INSTITUTION: University of Ontario Institute of Technology
("Ontario Tech University")
TITLE: Shawenjigewining Hall Interior Renovations
NO.: RFPOT03052026
ADDENDUM NAME: Questions and Responses
ADDENDUM NO.: 2

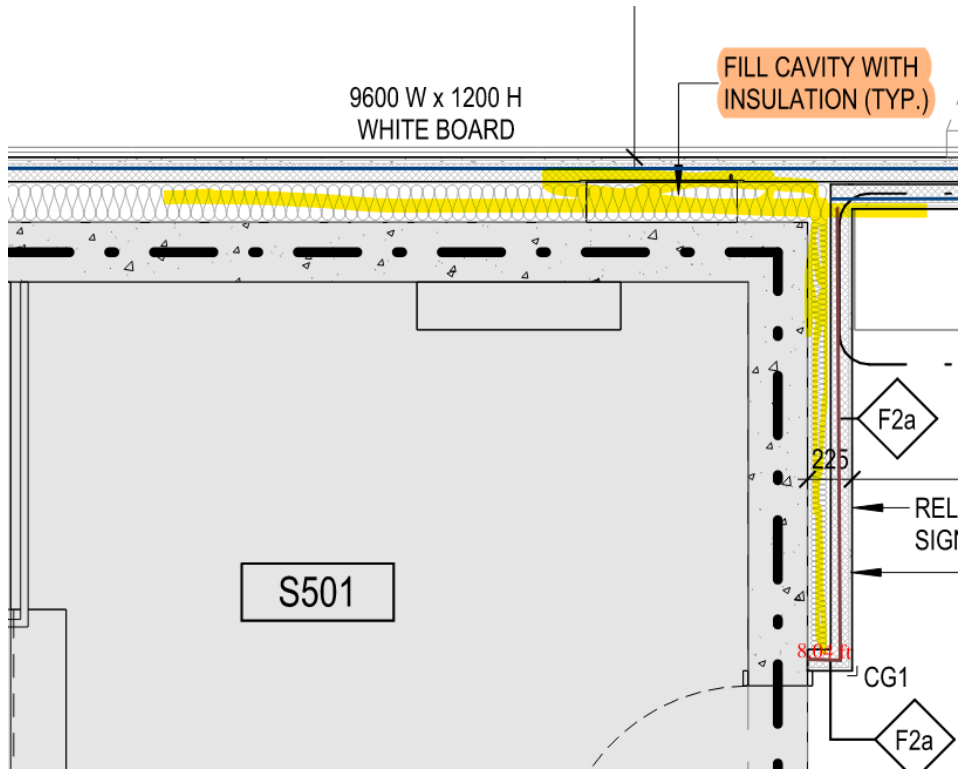
- 6) Could you please confirm if this wall (yellow highlight) is existing and we would only provide insulation and patch the wall?

RESPONSE: Highlighted area is a cavity behind the new wall and in front of the existing CIP concrete wall. It should be filled with insulation.

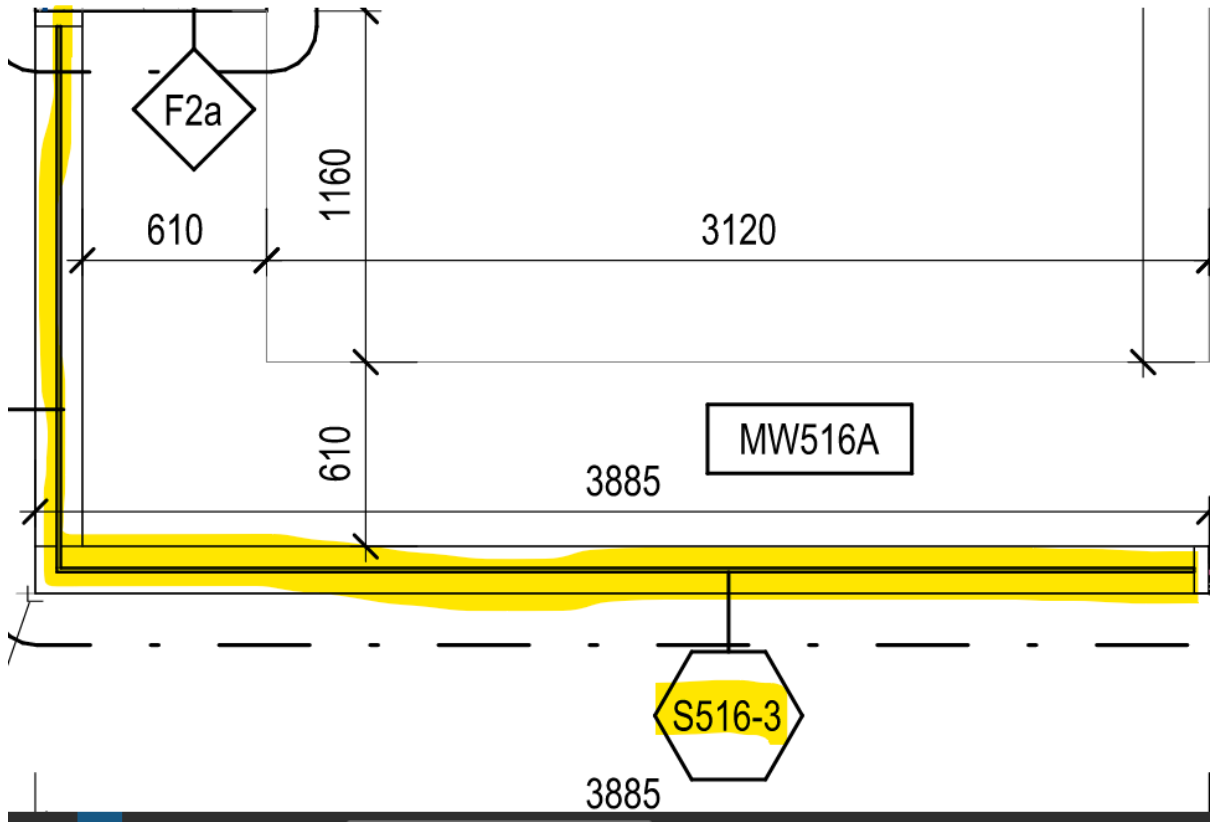
- 7) Should we just allow for bulkhead at this location? (typical everywhere)

RESPONSE: All walls are constructed to u/s of slab unless otherwise noted. Refer to A002 General Partition Notes #5.

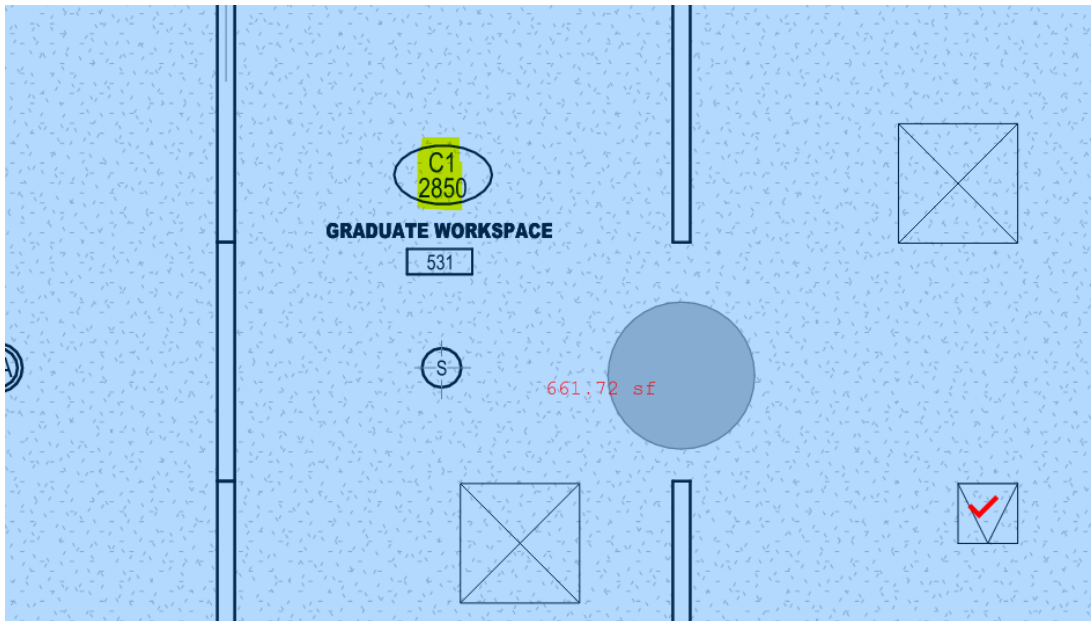
8) Is this a typo and should it be C3?

RESPONSE: Should be C3 in graduate workspace.

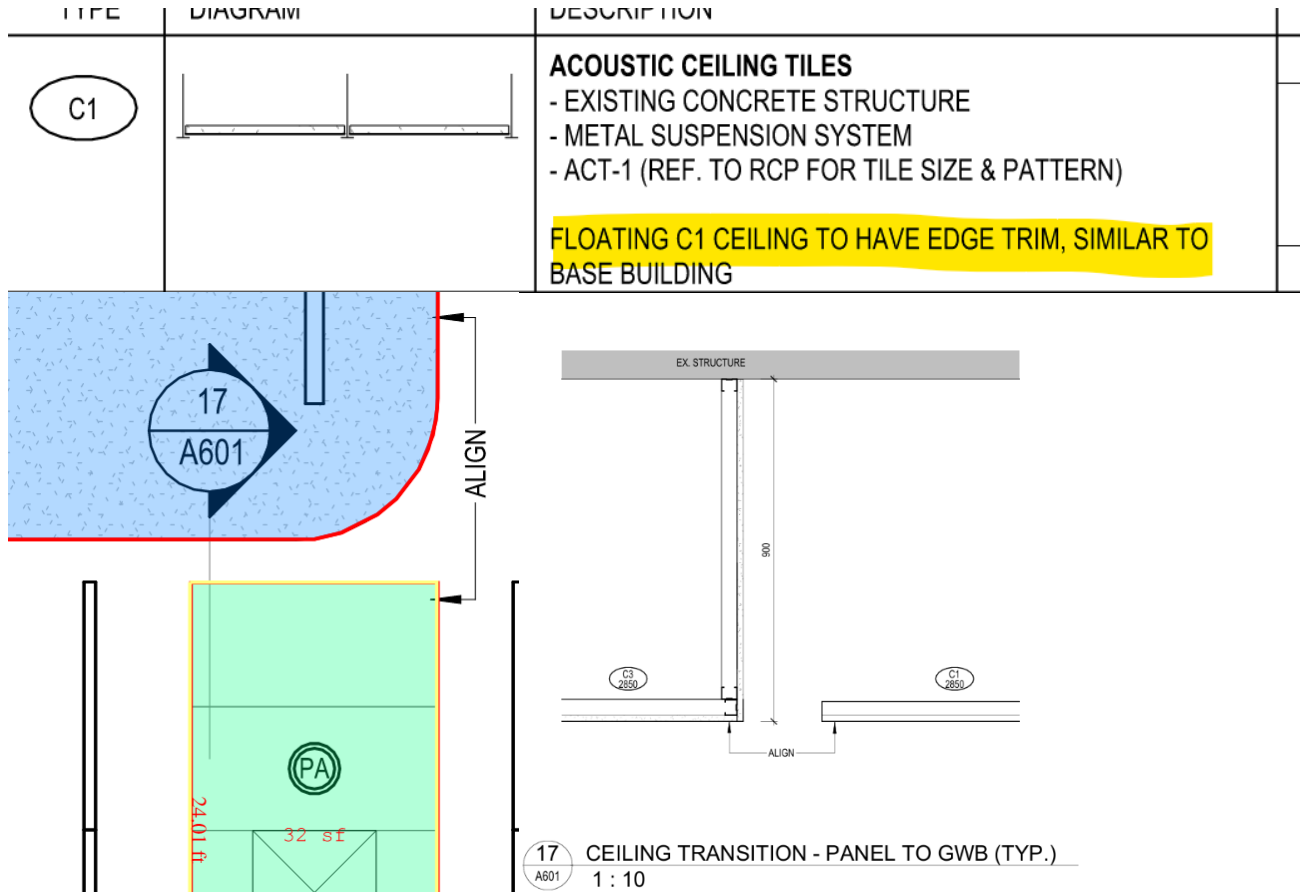
9) As per note C1, It says to provide edge trim. But section 17/A601 doesn't show any edge trim. Please advise if we require it there?

RESPONSE: Refer to specification section 09 51 13 subsection 2.2. ACT-1 used in C1 has an integrated square tegular edge.
